WATER POLLUTION CONTROL FACILITY

ELECTRICAL AND HEADWORKS BYPASS IMPROVEMENTS PROJECT

AS-BUILT

CLV PLAN# 311.57

RFI 030
DATE
APPROVED 07/11/2013

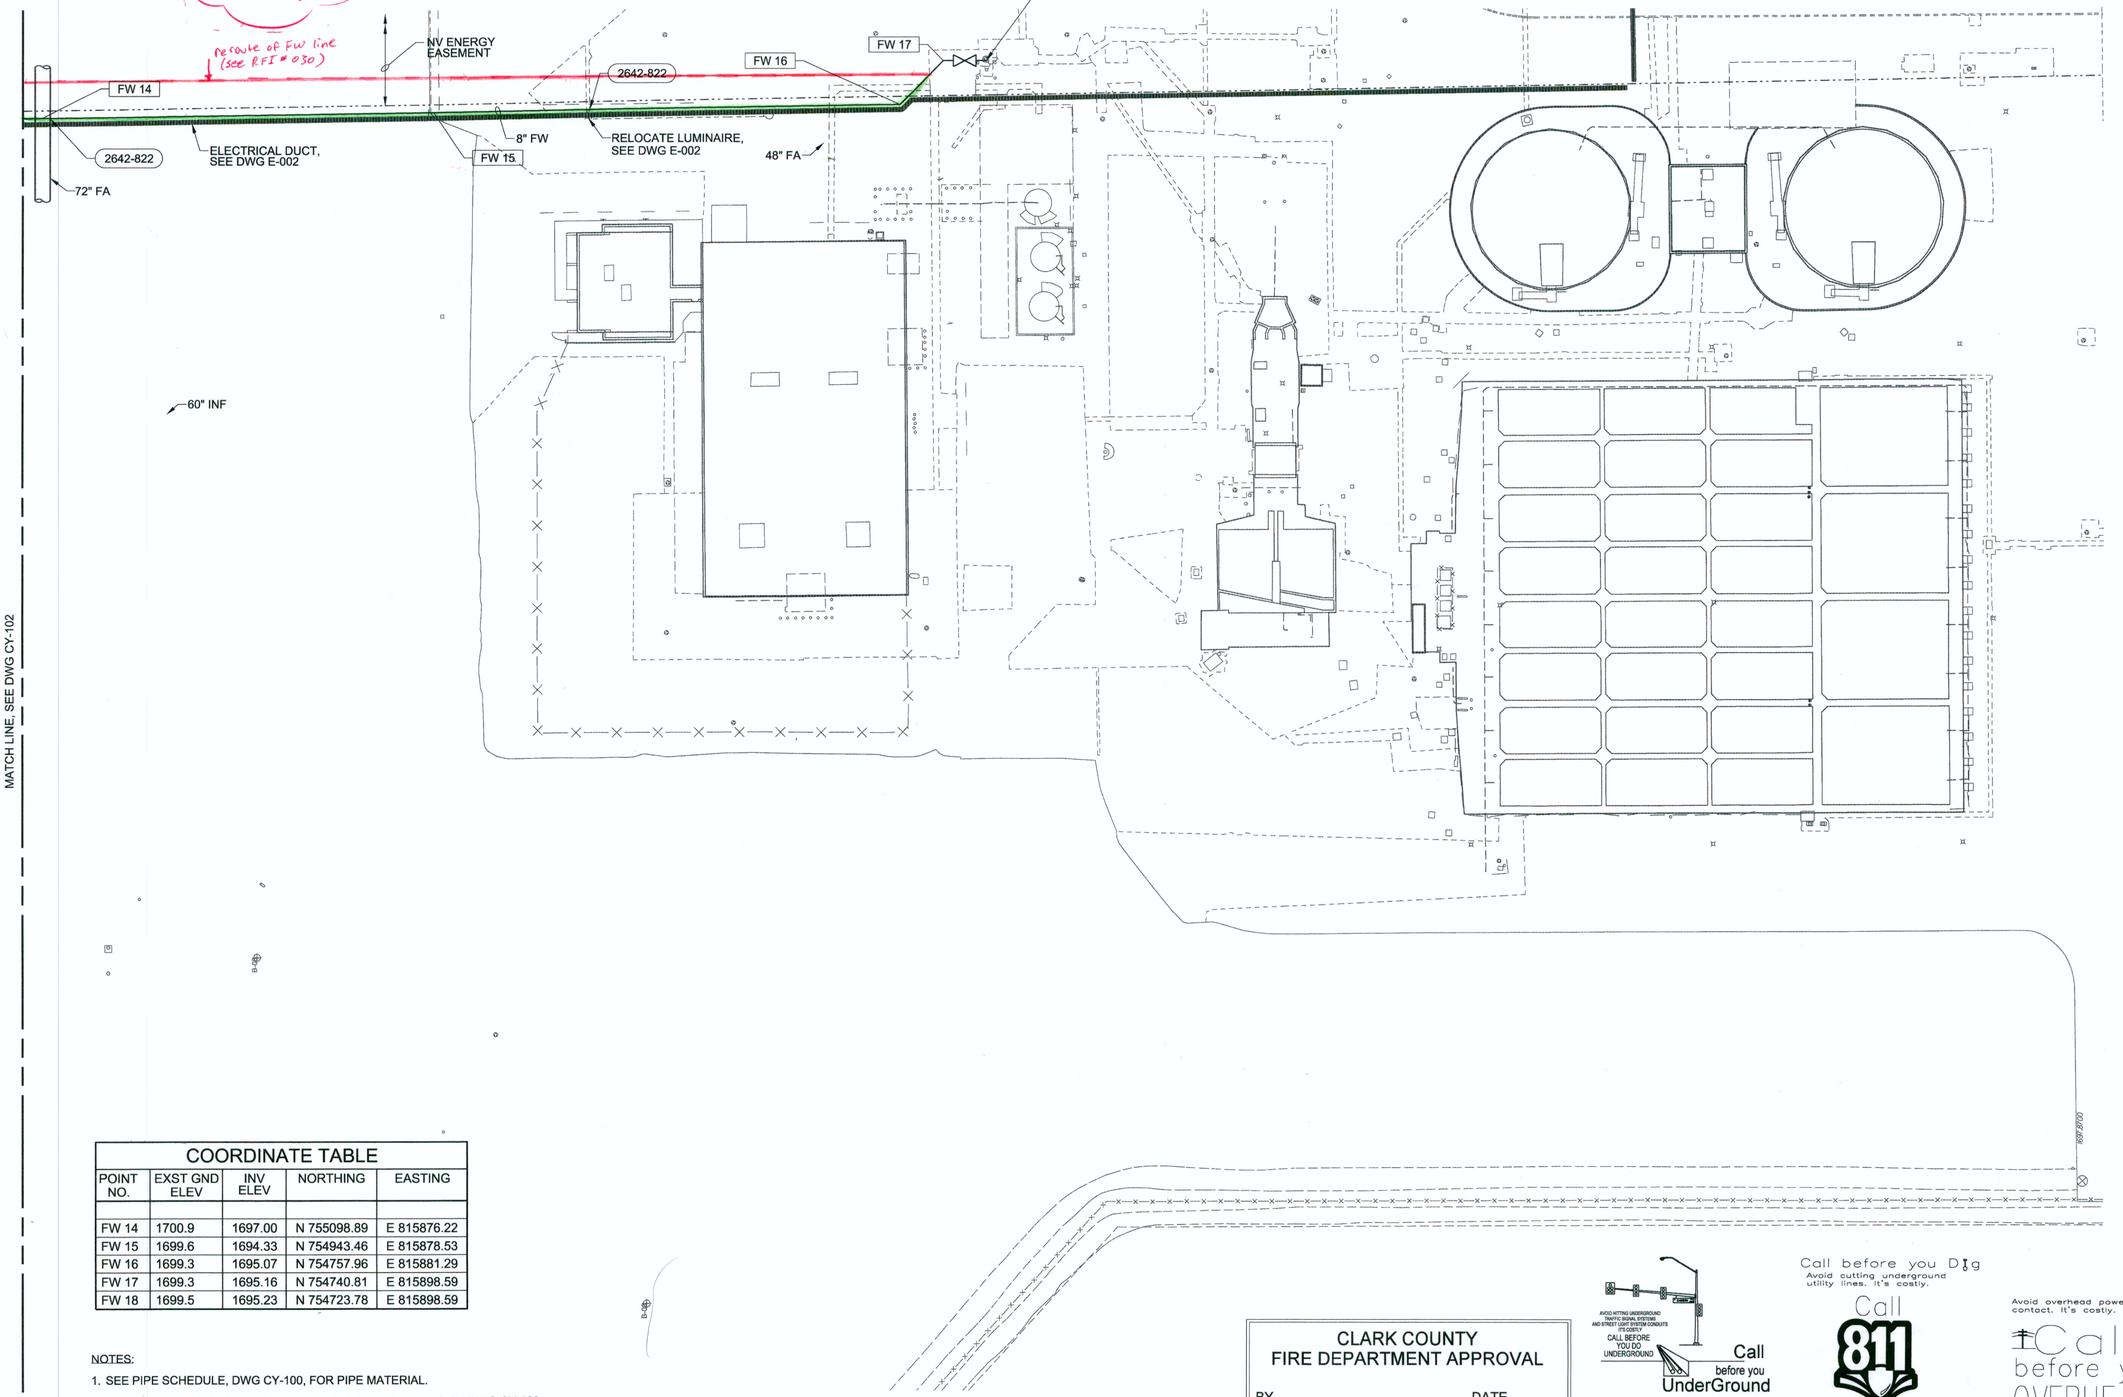
Reroute of FW line (see RFI # 030)

DATE	JANUARY 2013
PROJ	413455
DWG	E-014
SHEET	84

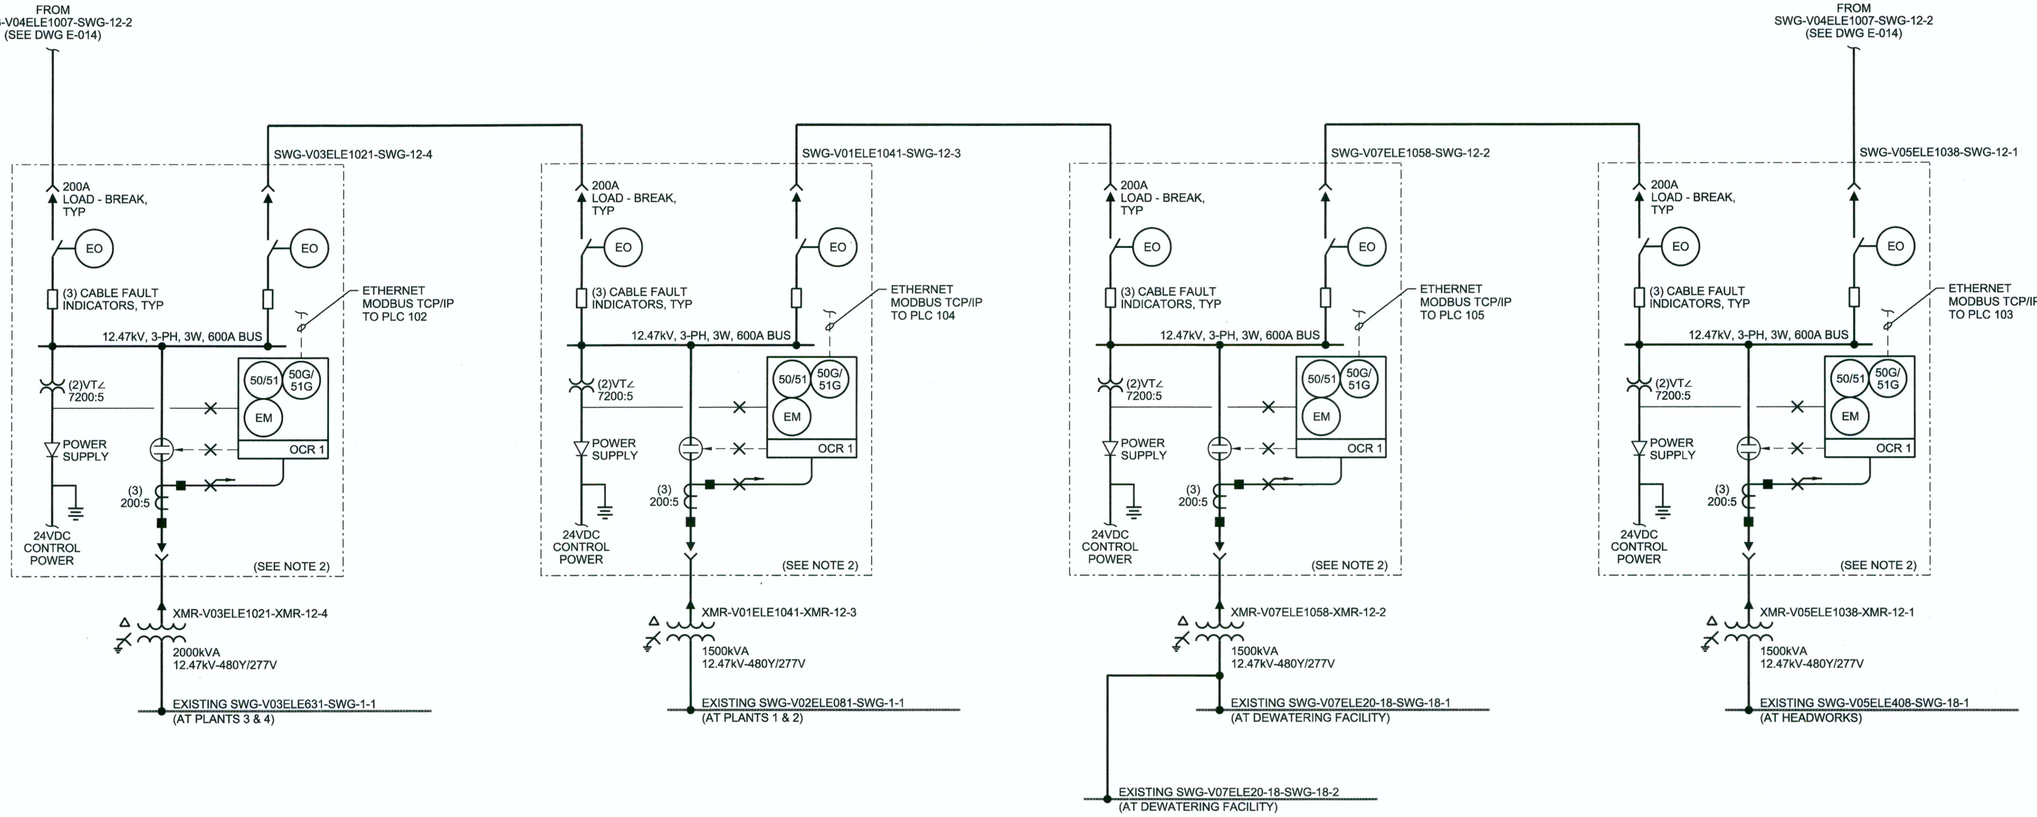
Reference E-014;
On sheet 84 appears to misrepresent the ATS tag number at the electrical distribution building. Please clarify

Reference E-014.
- Please confirm which kVA rating is correct, drawing E-014 shows 75kVA and on drawing E-013 states 225kVA. (see attached for clarification)
- Drawing E-014 also calls out XMR-V14ELE1007-XMR-12-3 and drawing E-013 calls out XMR-V04ELE1007-XMR-12-3. Please confirm which lab is correct. (see attached for clarification)
- Pre-Bid RFI #08 on 1/30/2013 states change ATS tag number to ATS-V04ELE1007-ATS-1-1. Please verify both ATS notes should change to that number? (see attached for clarification).

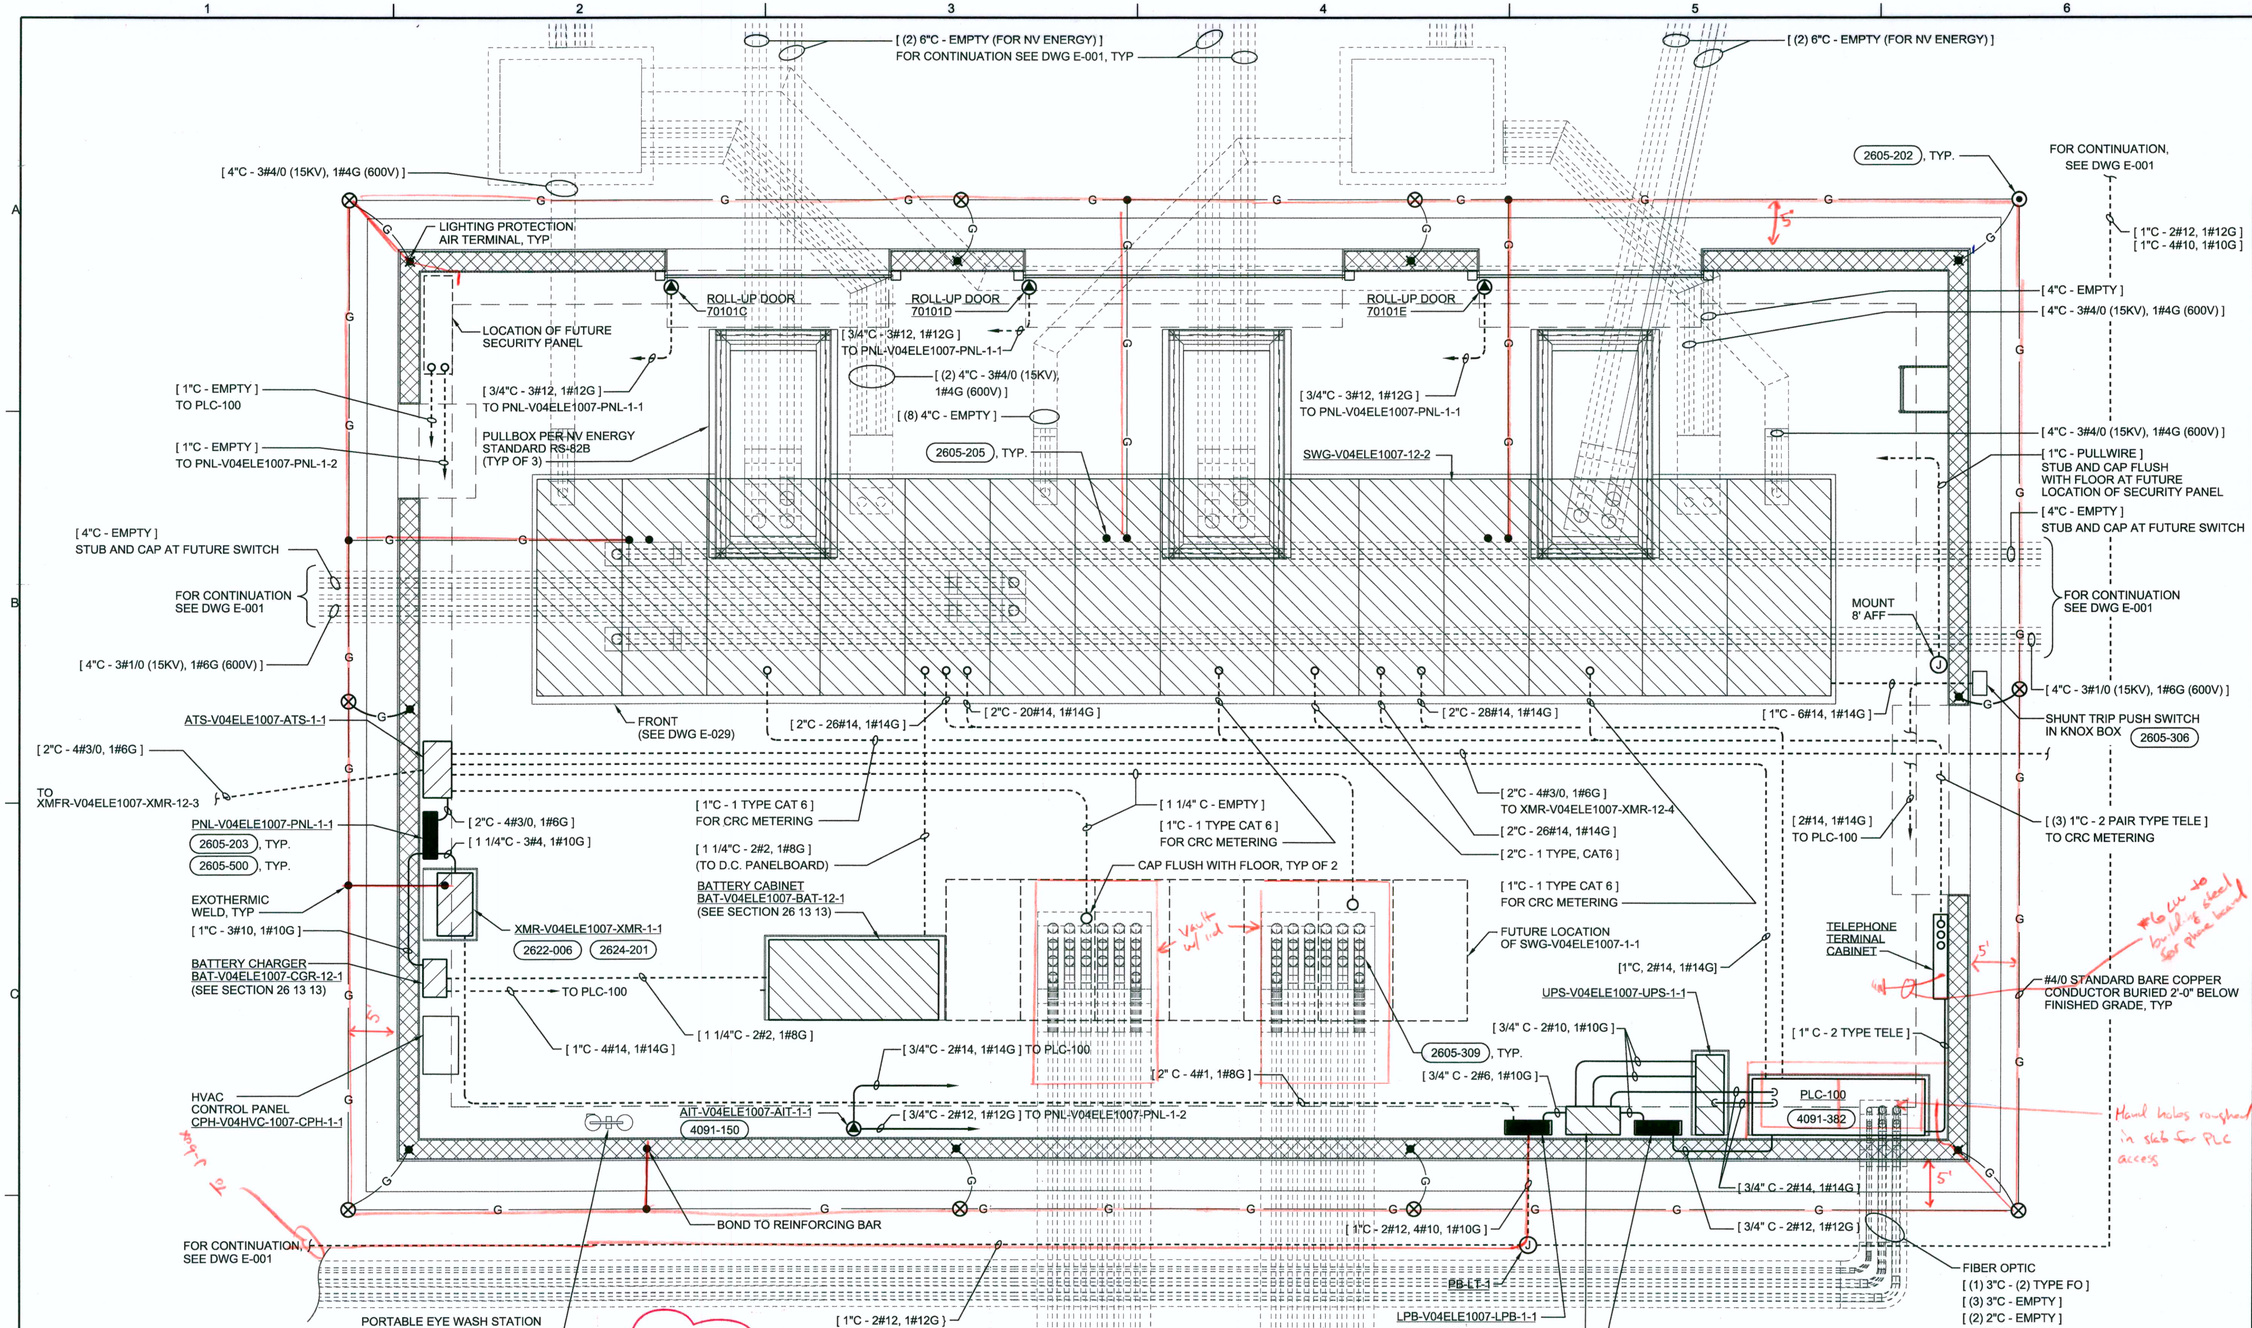
JCI control panel requires 120v power. Sheet E-701 does not show or call out for control power to panel.
Please advise as to how the design intends to feed the JCI Control Panel.

The proposed solution to run ¾ inch RGC from AIT-V04ELE1007-AIT-1-1 on wall to HVAC control panel and pull in new circuit from PNL-V04ELE1007-PNL-1-2 to HVAC control panel, is acceptable.
